Display

Model: **BKM-41HD, BKM-42HD**

Subject: **MODIFICATION FOR MULTIPLE FORMATS**

Figure 1

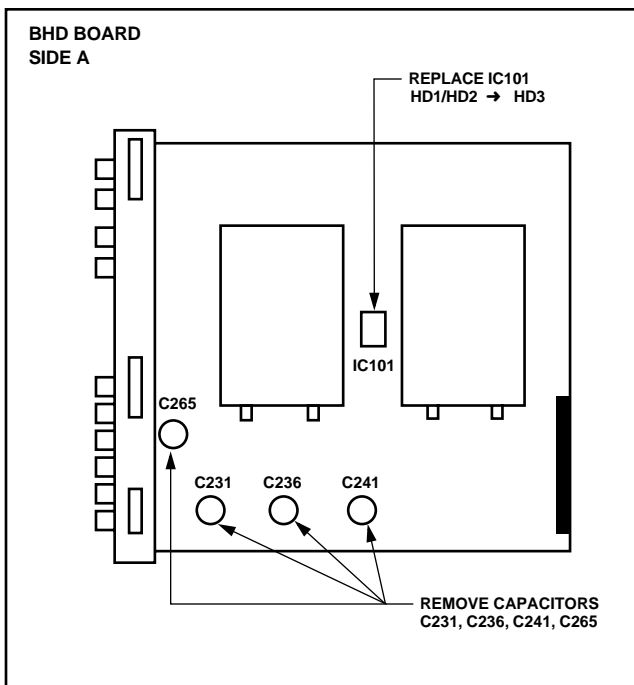
Side A

3. Replace former (PLD ROM: HD1 or HD2) IC101 (zone D-4) with new ROM.

If IC101 is not mounted on an IC socket, install an IC socket first then mount the IC.

4. Remove (47μF) capacitors C231, C236 and C241 (zones G-2/3/4, respectively).
5. Remove (470μF) capacitor C265 (zone E-1).

Figure 2

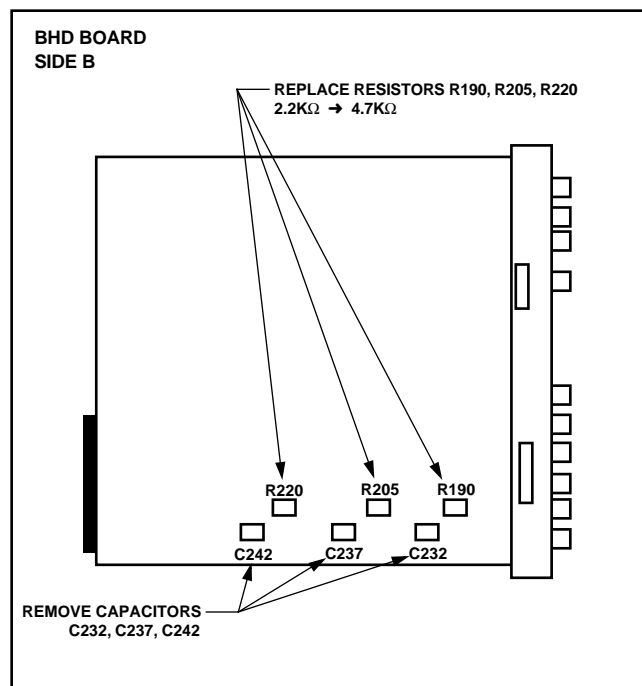
Side B

6. Remove (0.01μF) capacitors C232, C237, and C242 (zones G-6/5/4, respectively).
7. Replace former (2.2kΩ) resistors R190, R205, and R220 (zones G-6/5/4, respectively) with the new 4.7kΩ parts.
